SUBJECT: Forwards responses to Structural Engineering Branch 810403 request for addl info re 801201 submittal for expansion of spent fuel storage capacity.

H. B. ROBINSON STEAM ELECTRIC PLANT UNIT NO. 2
DOCKET NO. 50-261
LICENSE NO. DPR-23
REQUEST FOR ADDITIONAL INFORMATION CONCERNING
SPENT FUEL POOL EXPANSION

RESPONSES TO STRUCTURAL ENGINEERING BRANCH
REQUEST FOR ADDITIONAL INFORMATION
H. B. ROBINSON UNIT 2 FUEL STORAGE MODIFICATION

FIGURE 1

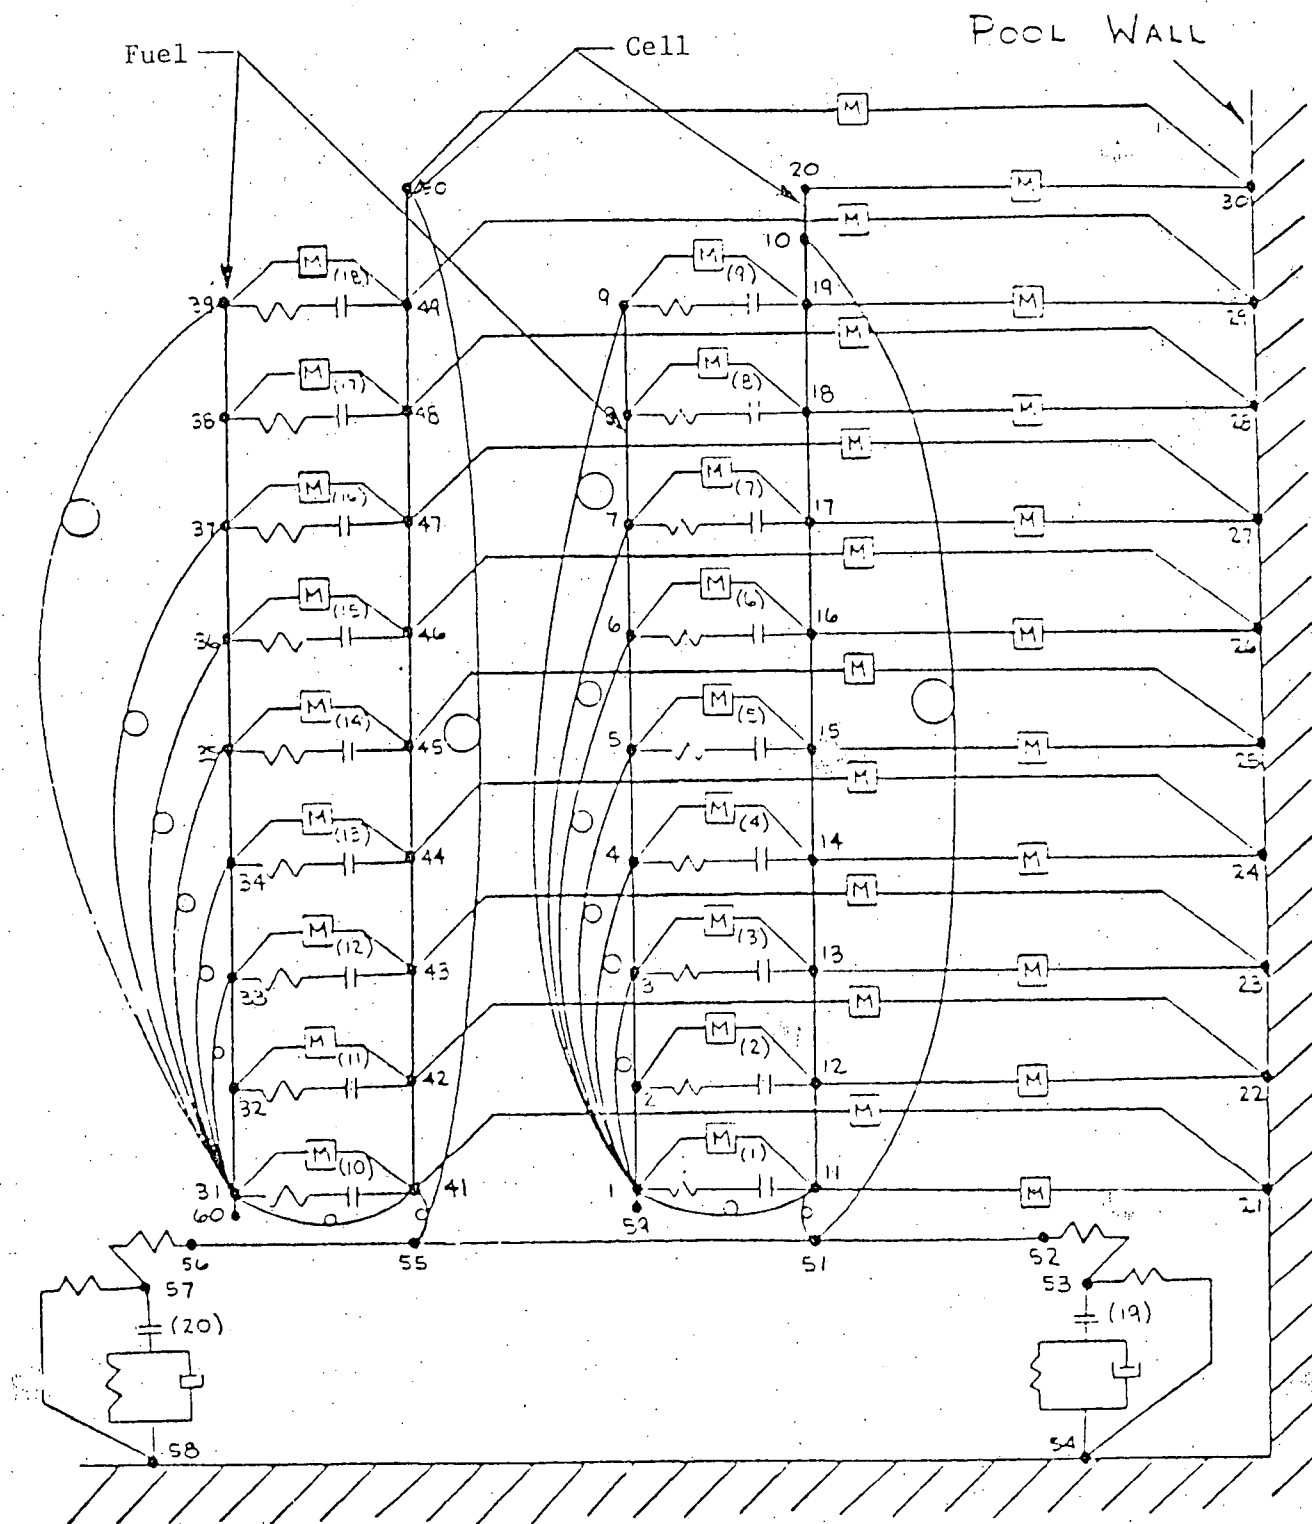
QUESTION: 4. Provide the nonlinear finite element model used in the time history analysis. Describe in detail how the nonlinearities due to gaps, friction losses and boundary conditions are accounted for in the model and analysis. Discuss, also, the analysis and provide justifications.

4. The H. B. Robinson nonlinear fuel rack model, shown in Figure 1, is a simplified flow-cell representation of a spent fuel storage rack with a fuel assembly contained within each cell. This model has two cells so that the analysis can be performed for fully loaded, partially loaded, and empty rack conditions by using two fuel assemblies, one fuel assembly, and no fuel assemblies, respectively.

Impact elements are used to model the impact phenomena between the fuel assembly and cell caused by the fuel/cell gaps. Friction interface elements are used at the rack supports to model liftoff, sliding and tipping behavior of the fuel rack. Since the fuel racks are located in the spent fuel pool which is filled with water, the effects of water on the response of the fuel rack system is included. The effects of surrounding water and water within cell assembly are modeled by using fluid (mass) elements. The spent fuel pool and fuel rack geometrical properties are used in determining the magnitude of hydrodynamic mass for the fuel rack system. The structural characteristics of the nonlinear fuel rack seismic model are obtained from the detail linear finite element model.

FIGURE 2 H. B. Robinson Unit 2 Horizontal SSE Acceleration Design Time History

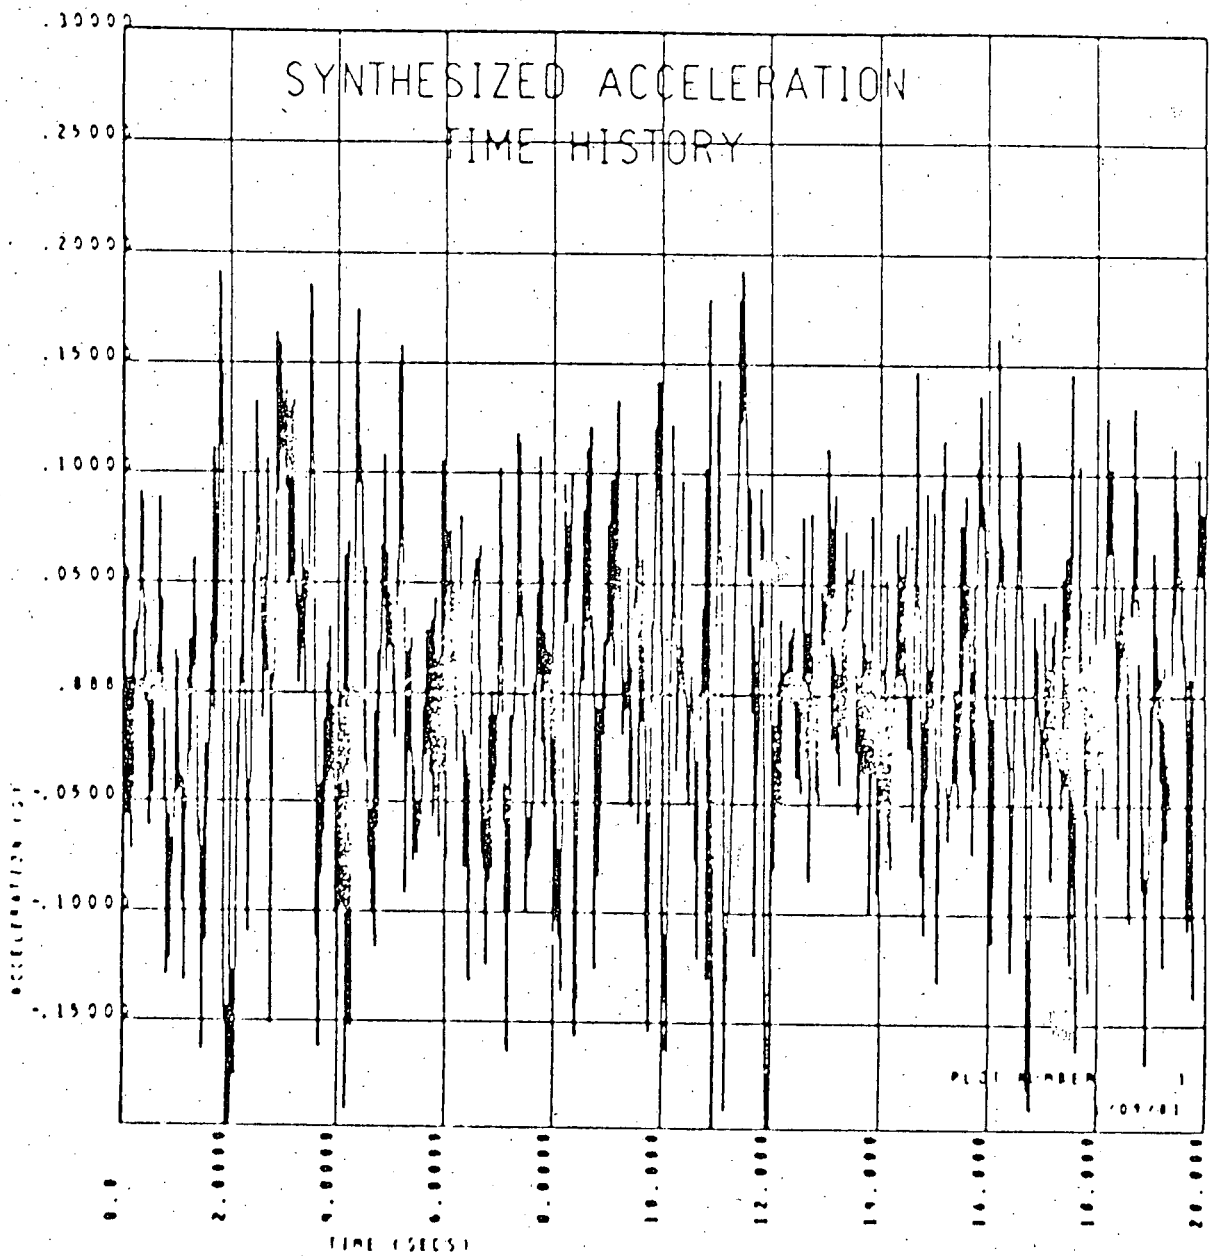
QUESTION: 10. Provide and justify the time history and floor response spectra used in the seismic analysis of the fuel rack assembly.

RESPONSE: 10. The seismic time history excitation used in the nonlinear analysis of the fuel rack assembly was developed from the ground response spectrum and damping values contained in the USNRC Regulatory Guides 1.60 and 1.61 respectively, using the ground acceleration of 0.20 G's horizontally and 0.134 G's vertically for the SSE event. Using this information, the design time history was synthesized. The synthesized acceleration time history for horizontal SSE and vertical SSE are given in Figures 2 & 3. In addition, response spectra developed from the synthesized time histories are represented
